DEVELOPMENT SERVICES DEPARTMENT STAFF REPORT

Project Name: Nove of Margate

DRC #: 23-400013

Application Type: Rezoning

[Applicant's Open Space Exhibit]

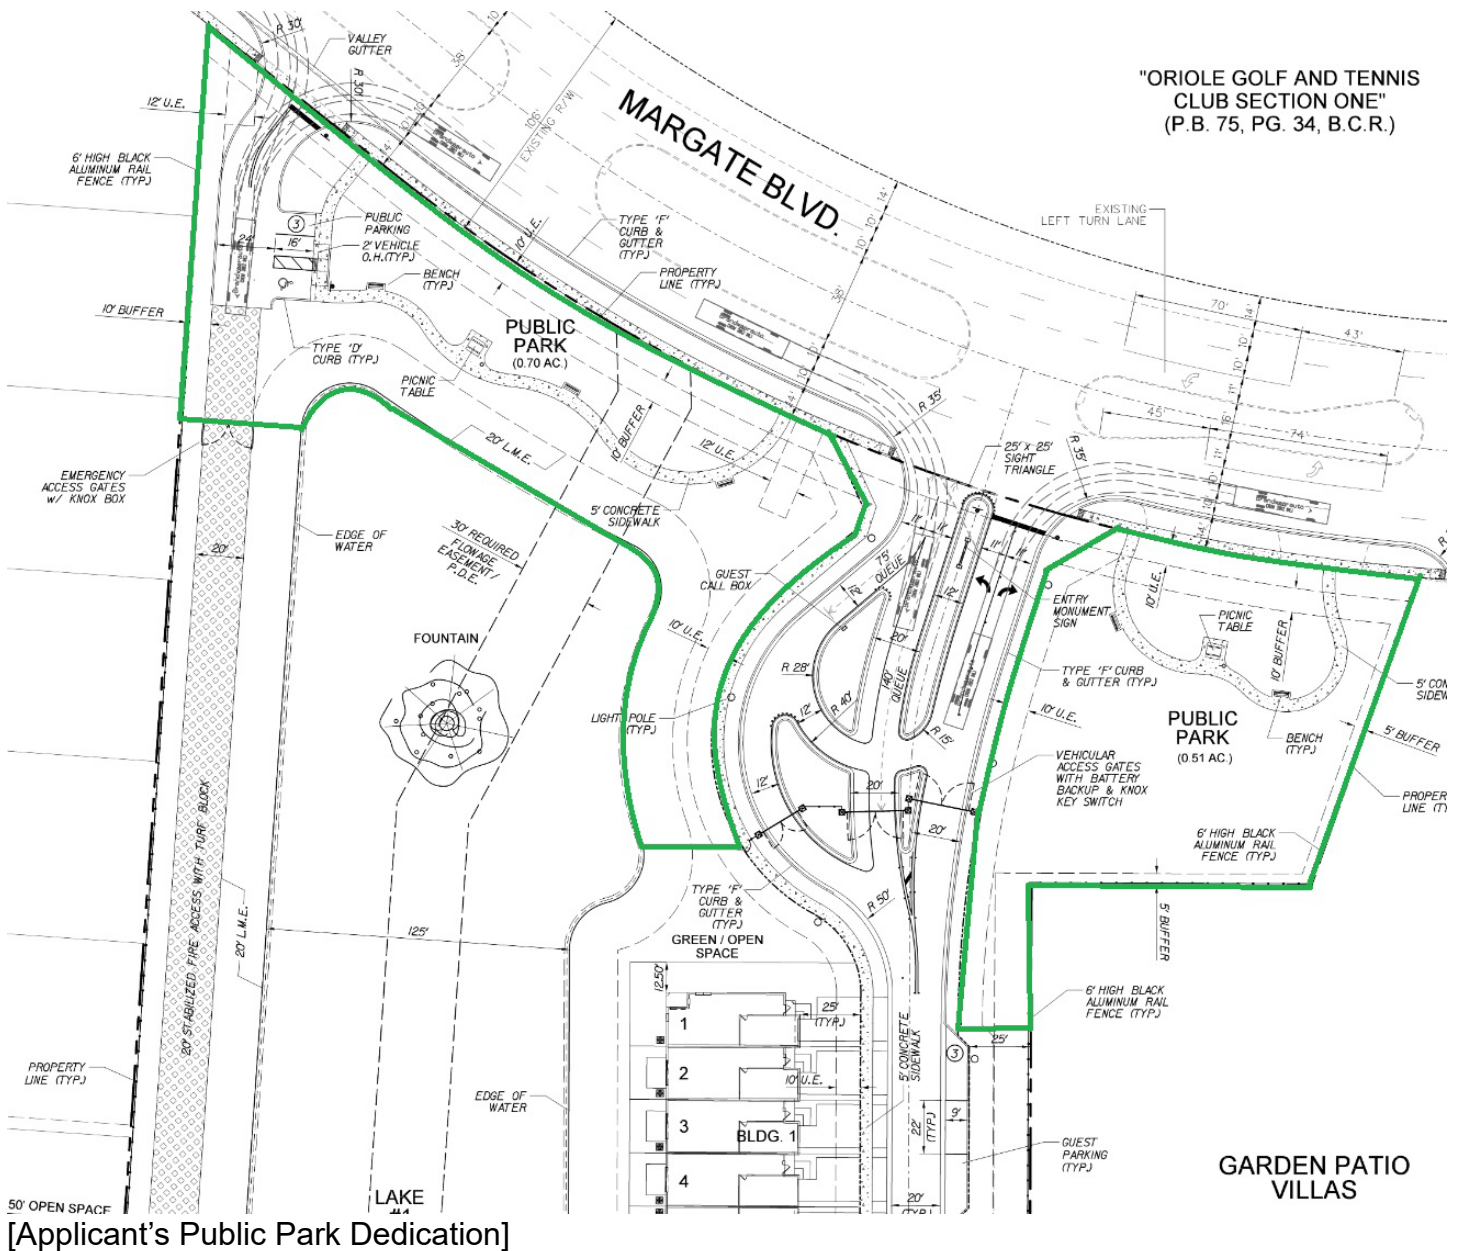
Either cite the verbiage in Sec. 19.11 (MZC) that allows this area to credit the open space requirement or remove it from the tabulation.

Either cite the verbiage in Sec. 19.11 (MZC) that allows this area to credit the open space requirement or remove it from the tabulation.

Either cite the verbiage in Sec. 19.11 (MZC) that allows this area to credit the open space requirement or remove it from the tabulation.

Either cite the verbiage in Sec. 19.11 (MZC) that allows this area to credit the open space requirement or remove it from the tabulation.

Revise gross acreage of 'residential lot' to only include fenced in portions of yards, per Sec. 19.11 (MZC).

Tabulation of 'other open space' includes a number of areas not specifically described in Section 19.11 (MZC). Revise.

'Public park' has the same credit value as 'recreation'. See Sec. 19.11 (MZC). Revise tabulation.

Response: A new sheet, Open Space Exhibit (Sheet SP-06) has been provided with this submittal. This plan shows all the areas included in the calculations in green. The definition of Open Space listed in Section 19.3 of the City Code permits this section to be counted towards the open space. Specifically, the definition of Open Space is as follows: "Open space: A generally unobstructed parcel or area of land permanently dedicated or reserved for the use and enjoyment of owners and occupants of the land within the PUD. Required open space shall be of a pervious nature and shall not be used for private roadways open to vehicular circulation; off-street parking or loading berths, lakes, canals, and other features may be considered as required open spaces to the extent of the limitations contained herein at Section 19.11, "Open Space Requirement and Computation." As this area is a generally unobstructed area of land permanently dedicated for the use of and enjoyment of the owners within the PUD, it meets the definition of Open Space and can therefore be counted towards meeting the open space requirements. More importantly, the PUD provides substantially more open space than required by Code.

Response: A new sheet, Open Space Diagram (Sheet SP-06) has been provided with this submittal.
